**Consultation Response from KC,
Highways Development Management**

2024/93017 51, Longcroft, Almondbury, Huddersfield, HD5 8XW

Conversion of garage to habitable accommodation and erection of fence

Revised Drawing Response

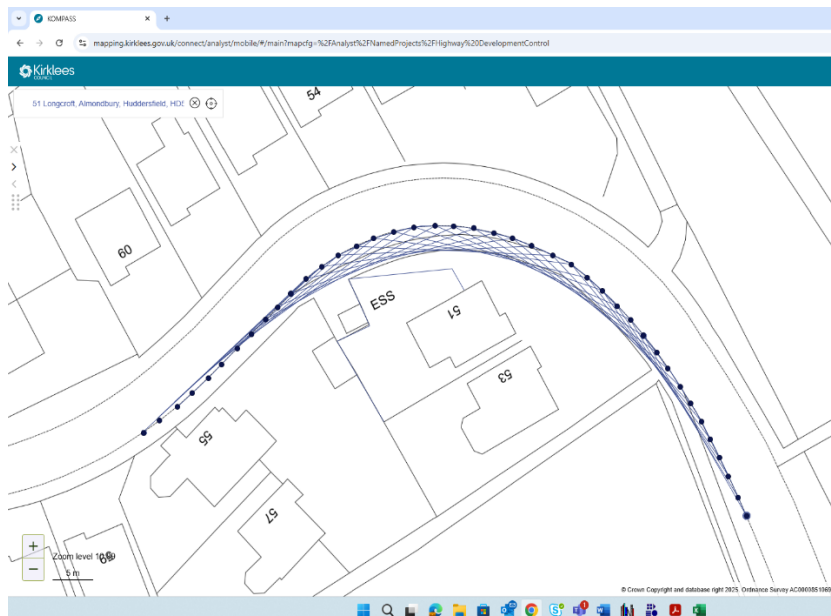
In the revised drawing the fence line has been shown to be offset by approximately 1m along the side connecting to the electricity sub-station. This would now allow for a 25m visibility splay to the right for vehicles exiting the garage/parking space for No 55 Longcroft, however we would request that a condition is added to ensure that anything within the area between the fence and the rear of the adopted footway is maintained to a maximum height of no greater than 1m to ensure clear visibility for drivers.

The 1m offset will also allow an increase of forward visibility around the bend on Longcroft adjacent to the application site.

Current highways design guidance requires that a 25m forward visibility length is available for this type of road, and this is displayed on the drawing below, showing the original proposed location of the fence.

This drawing has been constructed based on guidance given in Manual For Streets.

With this we are satisfied that the forward visibilities and the visibility splay for vehicles exiting the garage at No 55 are within standards and therefore would not like to object to the application but

Upon completion of the fence works as shown in approved drawing 0302-P03, sightlines along the frontage of the site between the fence line and the rear of the adopted highway on Longcroft shall be cleared of all obstructions to visibility exceeding 1 m in height and these shall be retained free of any such obstruction throughout the lifetime of the development.
